ADDENDUM 02

Date: 08-23-2024

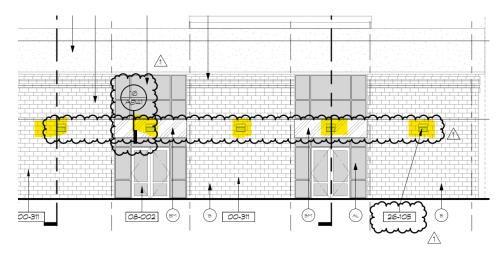
- 1. When can we expect to see a spec sheet for all of the signage components? The Project Overview does not have any specific call outs (material, depth, size and install method etc) on the Exterior, Interior, Donor, Door & Wayfinding signage.

*Correct. This is a design-build RFP.
- 2. Will we provide a style guide for all font size, etc?
